Eddy Building – Detached Addition : Addendum #5

DATE: October 23, 2024

Hobbs Architects, PA
159 West Salisbury Street
PO Box 1457
Pittsboro, North Carolina 27312

ADDENDUM #5:

DATE 9/6/24
A-101 ALT

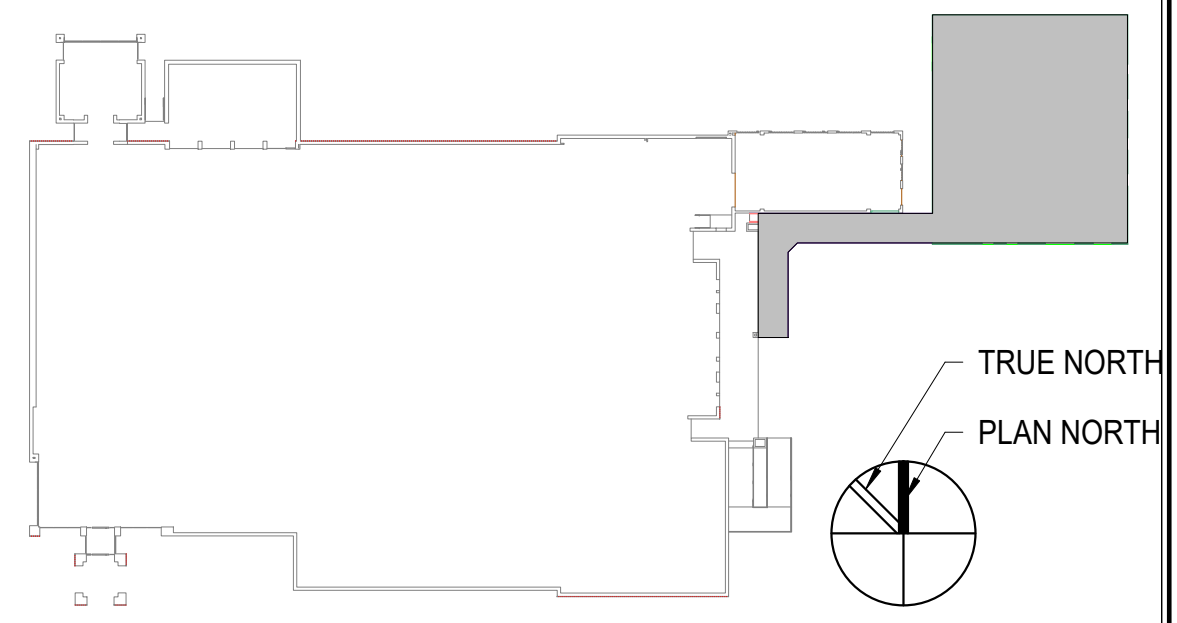
1. Clarification: There will be no Section 01 21 00 Allowances issued for this project.
2. Clarification: Please see updated drawing sheets that reflect a clarification to infill of mechanical yard metal gate that is part of Alternate G-1A.

1. Base bid: Includes no hydraulic dock lift or associated metal stair and landing inside the building addition.
2. Alternate G-2: Includes total cost to provide and install hydraulic dock lift and associated metal stair and landing inside the addition as shown on Sheet A-101 ALT.

- NEW HYDRAULIC DOCK LIFT - SEE SPECIFICATIONS
- DEMOLISH EXISTING MTL. GATE FOR MASONRY INFILL TO MATCH EXISTING SCREENWALL
- DEMOLISH EXISTING MTL. & CONCRETE STAIRS FOR SLAB INFILL
- NEW PREFABRICATED ALUMINUM CANTILEVERED CANOPY. SEE WALL SECTIONS AND SPECIFICATIONS.
- DEMOLISH PORTION OF EXISTING BRICK WALL, PREPARE FOR NEW MTL. DOORS.
- NEW METAL GRATE STAIR AND LANDING - SEE SPECIFICATIONS.
- PROVIDE NEW DOCK BUMPERS AT EXTENDED LOADING DOCK - SEE SPECIFICATIONS
- PROVIDE NEW PAINTED METAL GUARDRAIL AT REAR OF LOADING DOCK WHERE SHOWN. WELD RAIL TO EMBED PLATE SET IN EXPOSED SLAB EDGE OF ELEVATED WALKWAY. SEE SPECIFICATIONS.

DATE
9/6/24
**A-302
ALT**

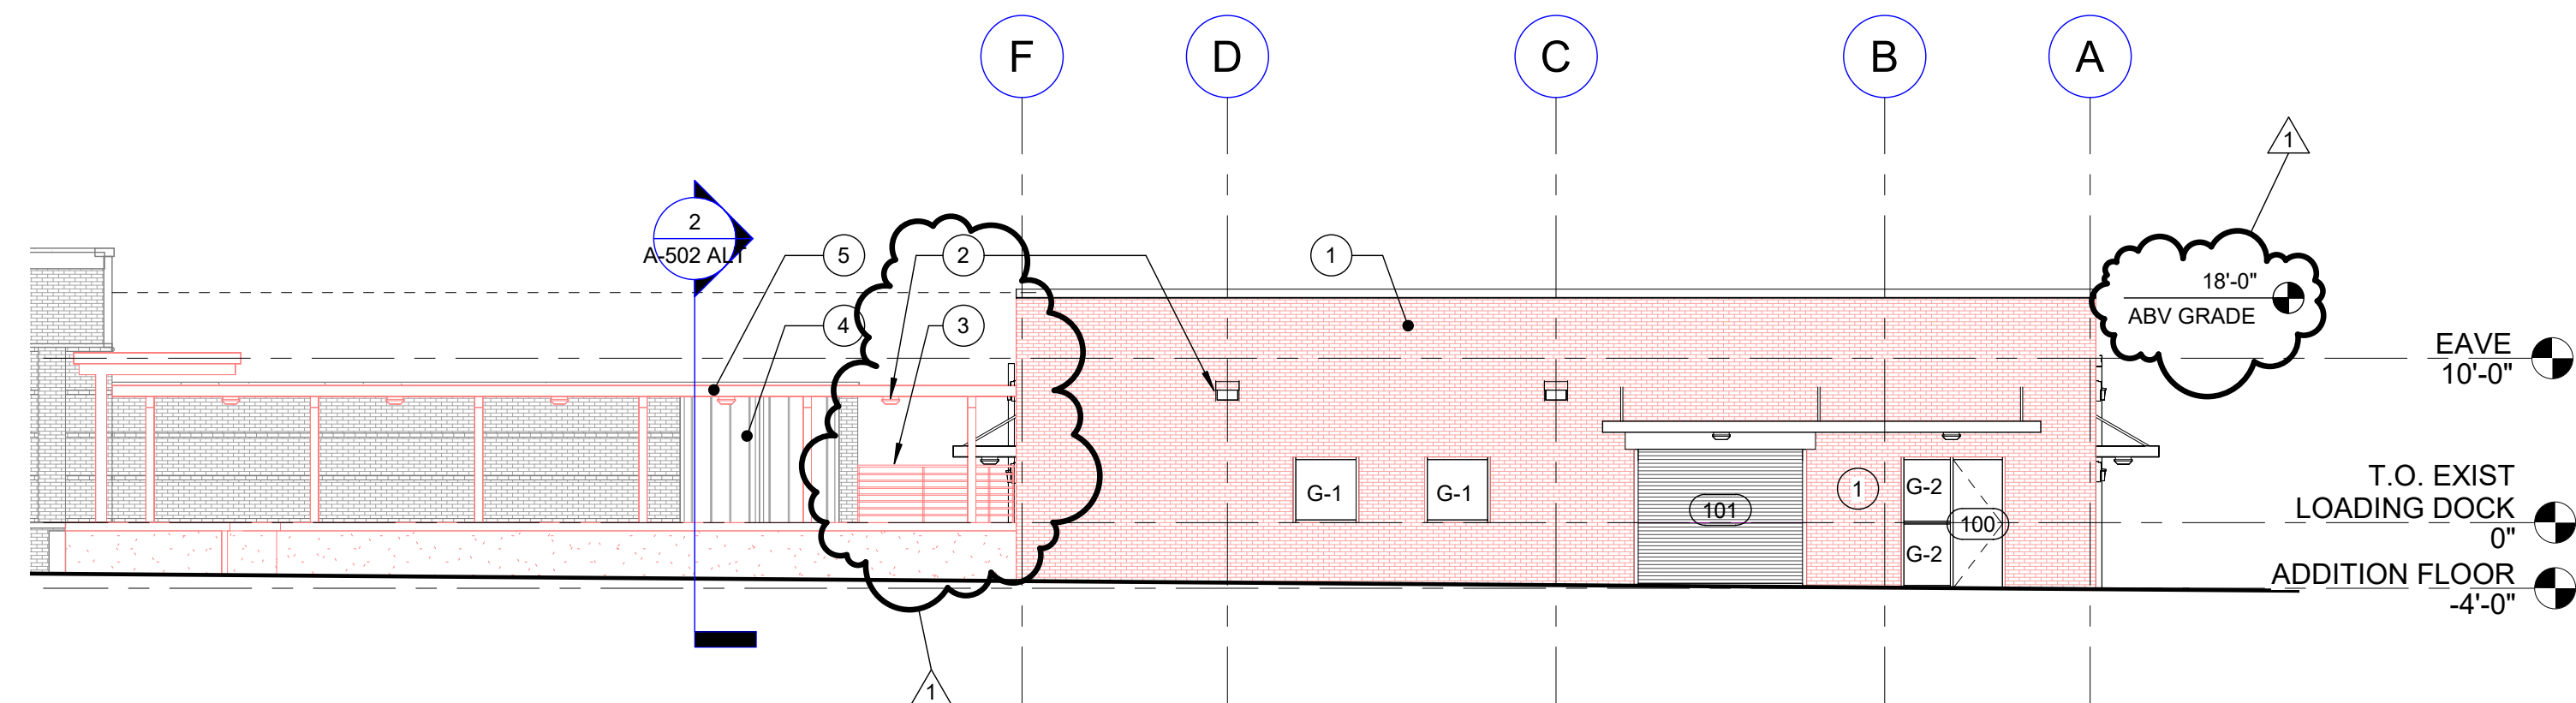
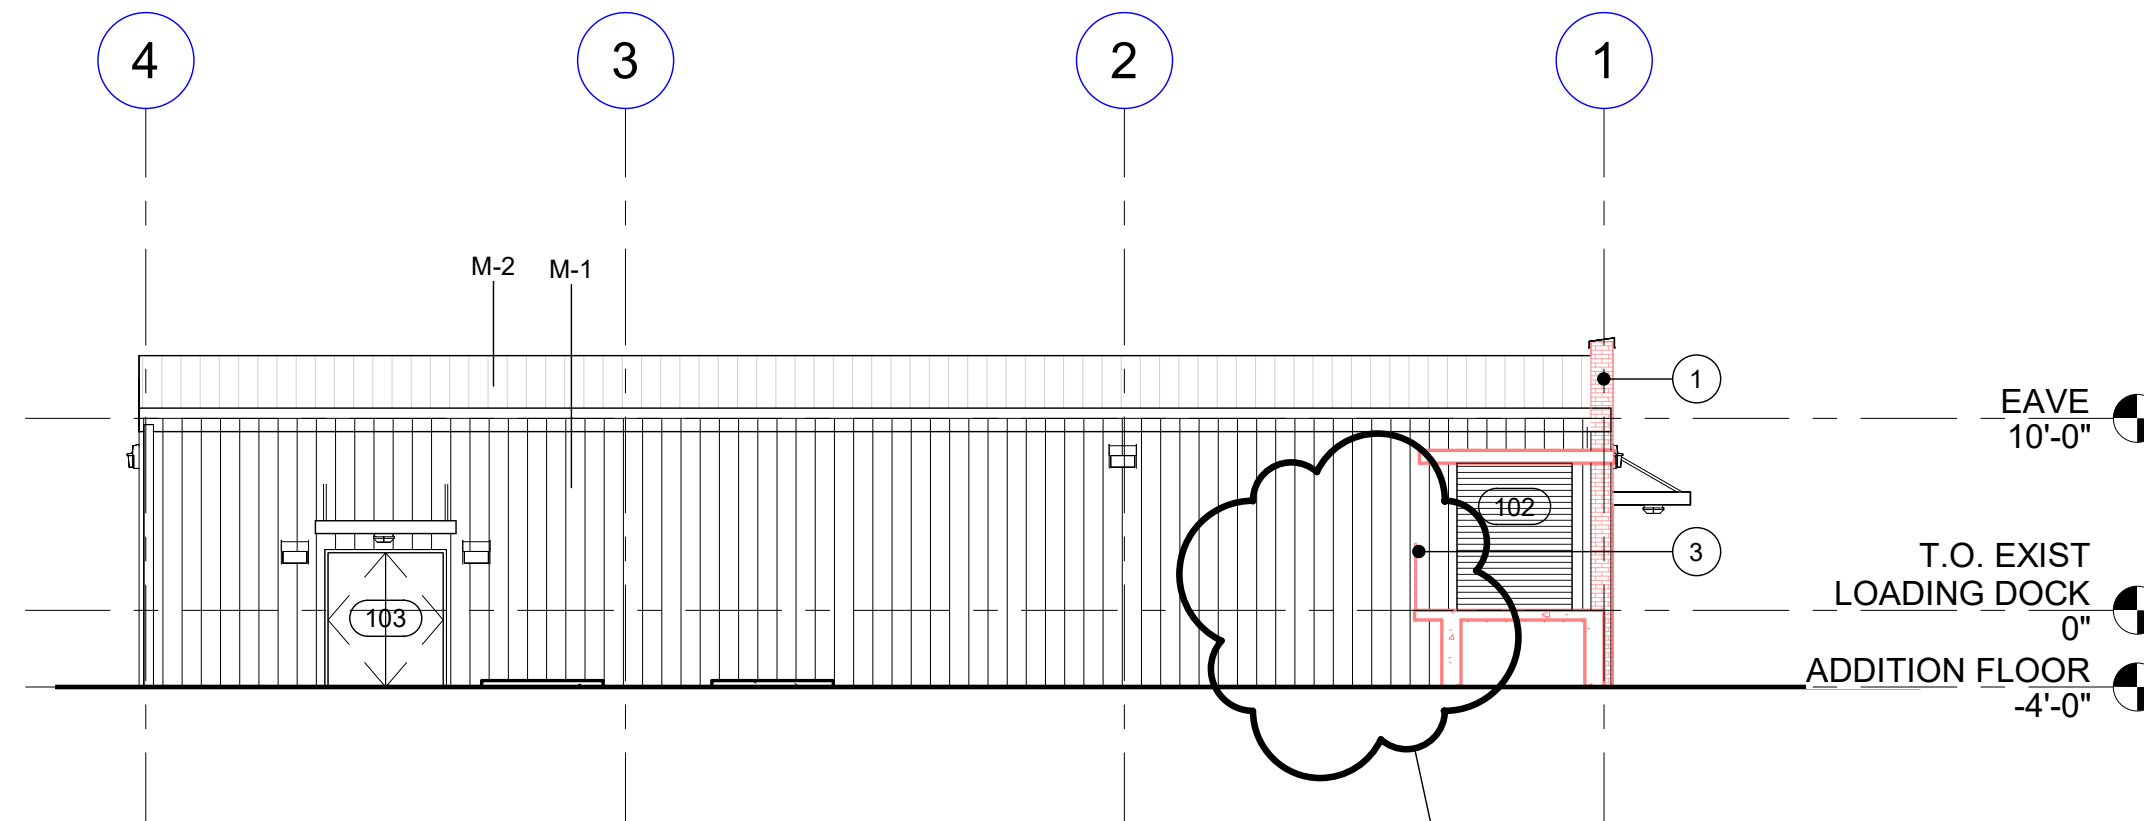
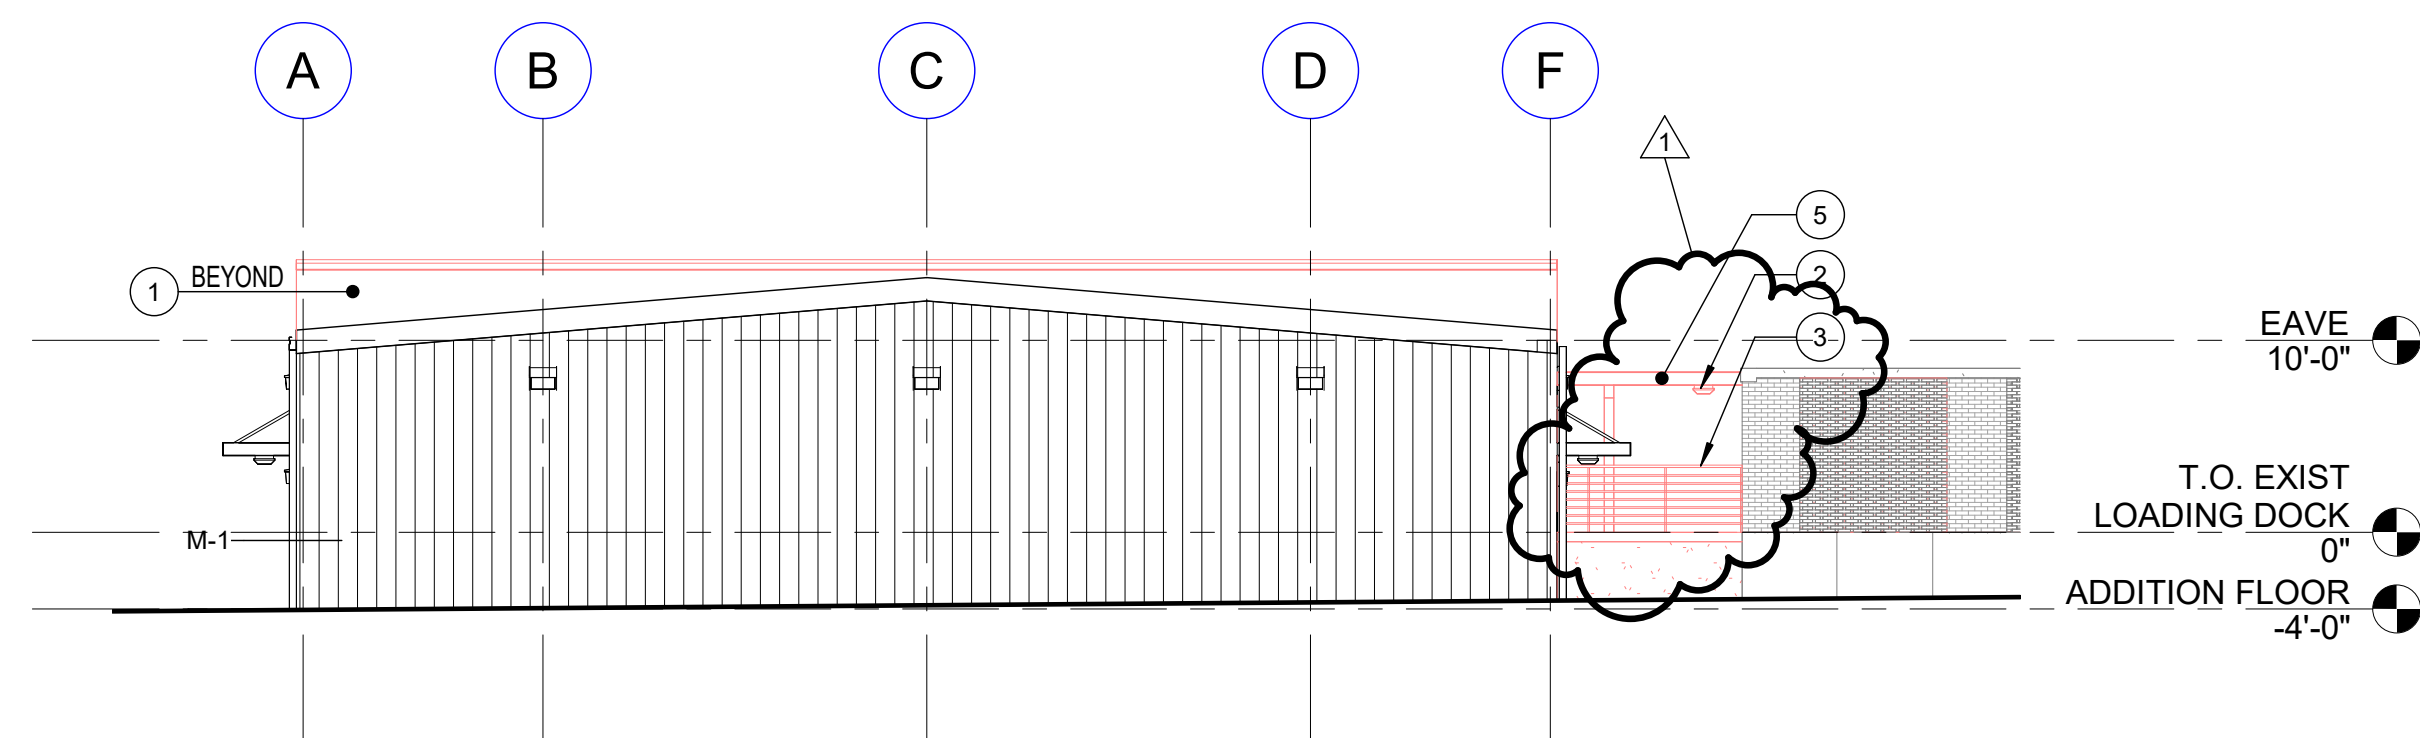
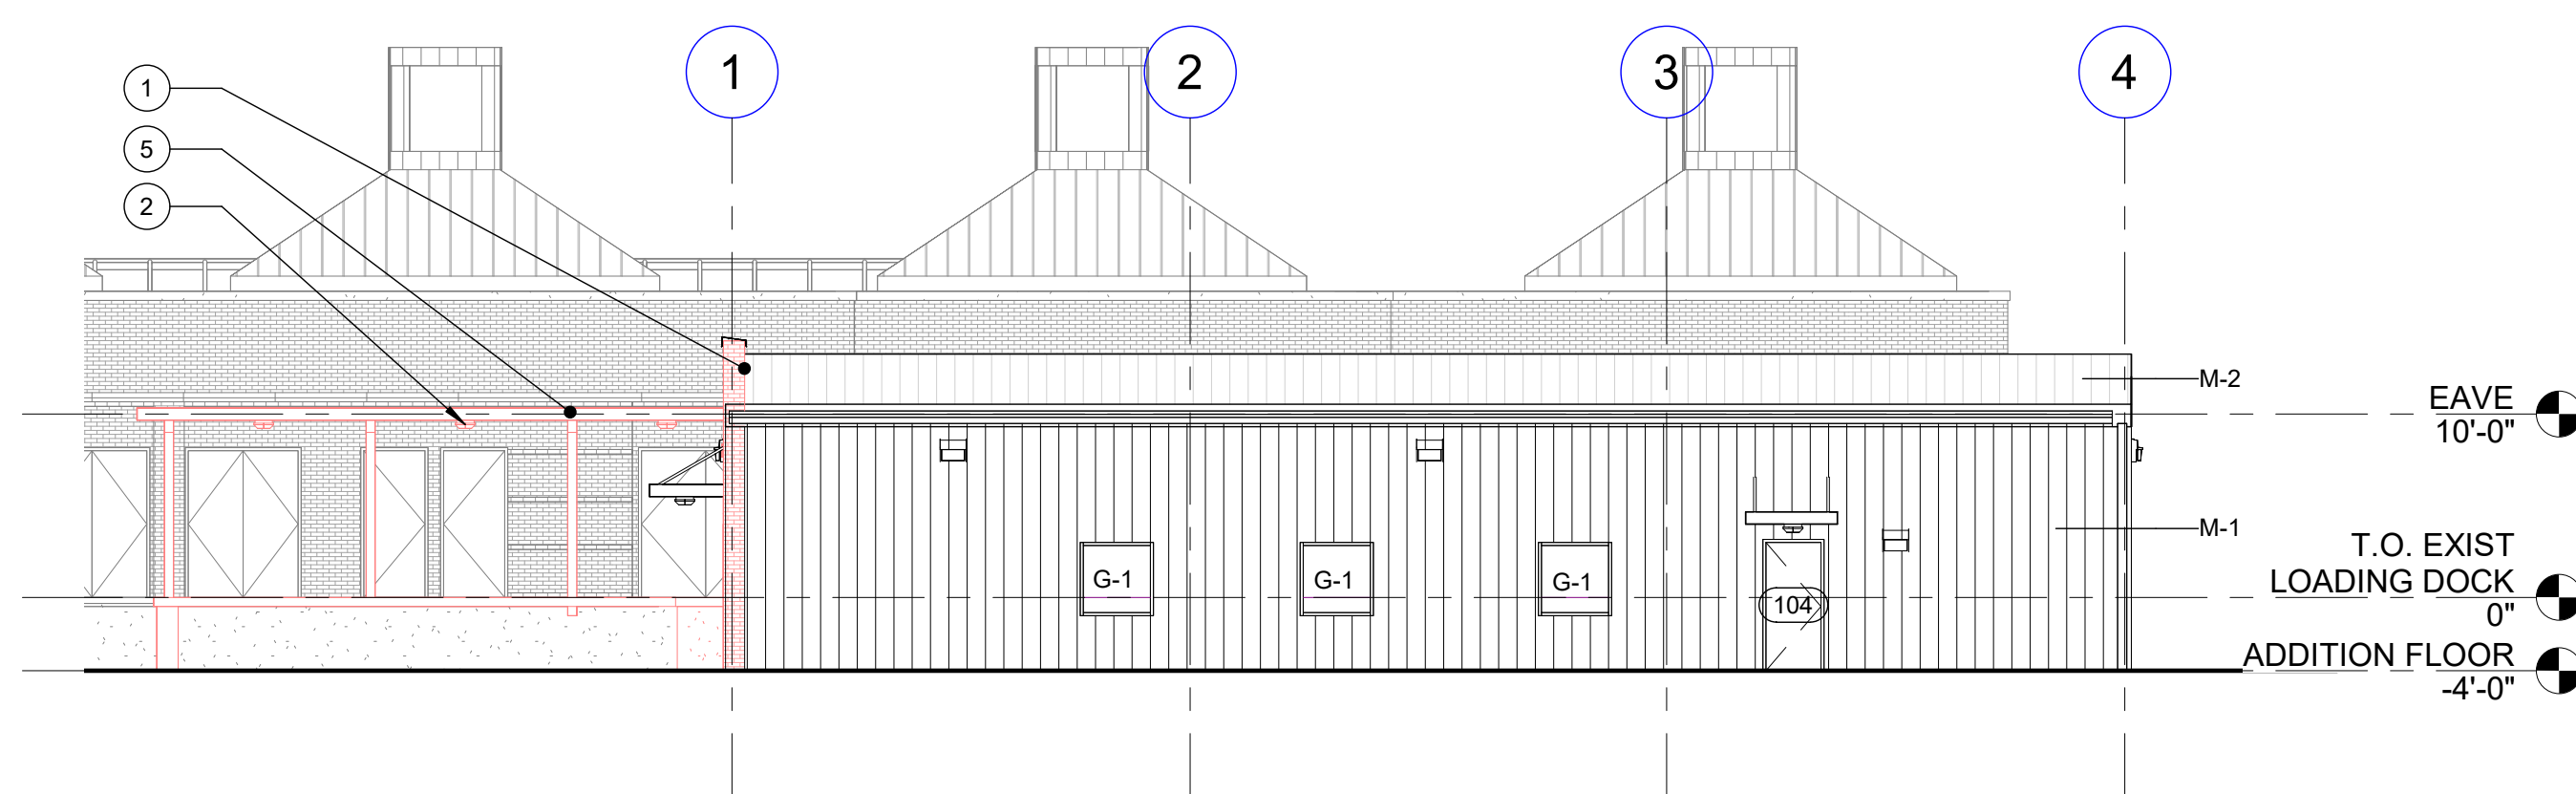
6. Can you please provide the height to the top of the parapet wall shown on the alternate elevation page?
 1. RESPONSE: Brick parapet is 18' above finish grade.

10. Please provide additional details and clarification to the removal of the gate and infill of the masonry screen wall. The drawings only note the gate removal and show the infill as all brick infill for an opening that is roughly 9'-4" x 4'-3". As shown in the attached pictures, this gate is the full height of the screen wall and also has a concrete knee wall and precast concrete cap. Please clarify what the intent is for the infill and provide additional details as necessary.

1. RESPONSE: See updated sheet A-302 ALT and A-502 ALT included in this addendum.
11. General note 5 on sheet E-101 states that automated lighting controls are not include inside the building due to safety concerns. Does this include the astronomical time clock that is tied to the exterior type C light fixtures? Or should that be included in our bid?

- 1 NEW BRICK VENEER ON 8-1/4" METAL STUDS, PART OF ALT. G-3
- 2 EXTERIOR LIGHTING - REFER ELEC DWGS, PART OF ALT G-1B
- 3 NEW PAINTED MTL GUARDRAIL, PART OF ALT G-1A, 42" H., SEE SPECS & 2/A-502 ALT
- 4 NEW BRICK INFILL AND PRECAST COPING TO MATCH EXISTING, PART OF ALT G-1A, SEE 2/A-502 ALT
- 5 NEW PREFABRICATED ALUMINUM CANTILEVERED CANOPY, PART OF ALT. G-1B, SEE A-502 ALT WALL SECTIONS AND SPECIFICATIONS.
